North Hertfordshire District Council

Building Conservation comments

File Ref: 24/01859/FPH & 24/01860/LBC

Subject: Single storey rear extension and alterations to existing rear extension roof following demolition of existing conservatory. Internal and external alterations.

Figure 4 – Assumed Building Phases Existing Building

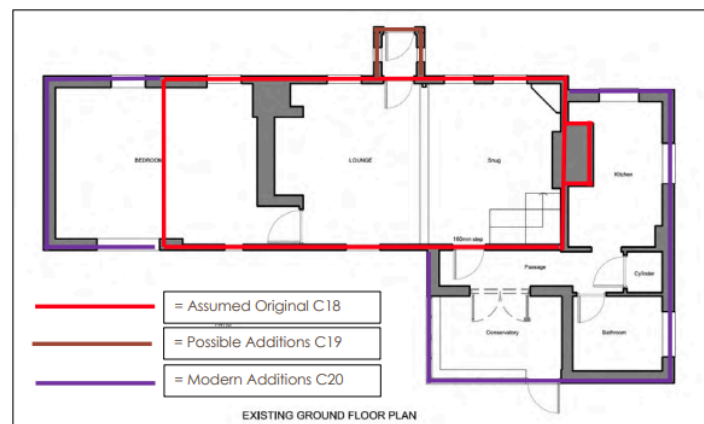
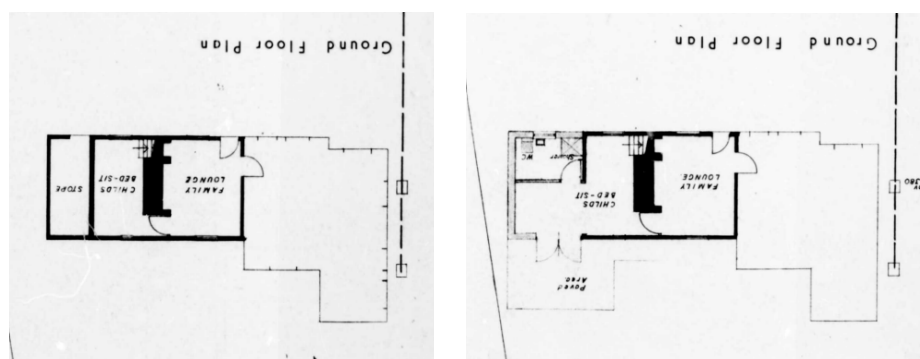
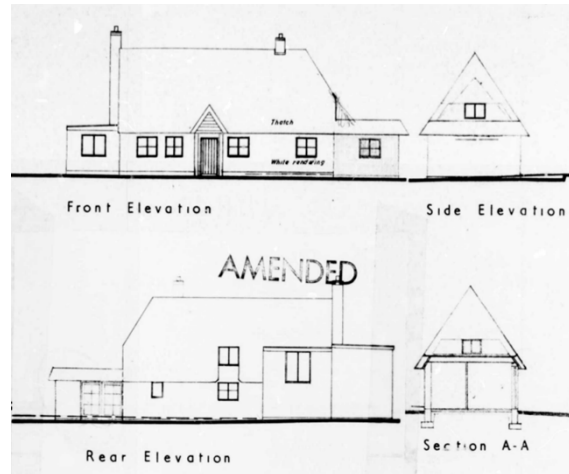
- 4.2 The above, in my opinion, requires just a little unpicking based on the existing and proposed ground floor plans submitted under ref: 74/00549/1 for a single-storey side extension. I have intentionally turned these plans upside down to read more easily alongside Fig 4 above. Part of the building is only shown in thin outline on the 1974 plans as this part of the building was not affected by the proposal. I agree with the view that the side extensions (except for the conservatory) existed in 1974 i.e. pre-listing. There is no planning history for the conservatory which may be unauthorised and does not appear on either ref: 74/00549/1 or 79/00140/1. It would certainly have required LBC if built post May 1987. Having said that, I raise no objection to its demolition.

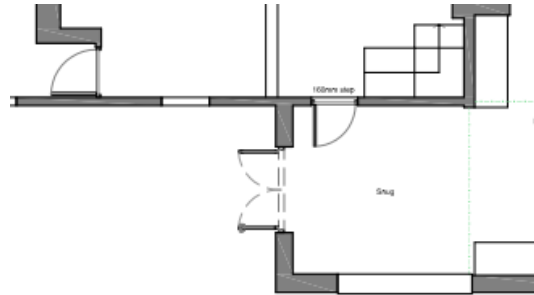
- 4.3 As noted on the 1974 elevation drawings below, there seems to be a drafting error with the height of the right-hand addition as viewed from the rear, which is too high.
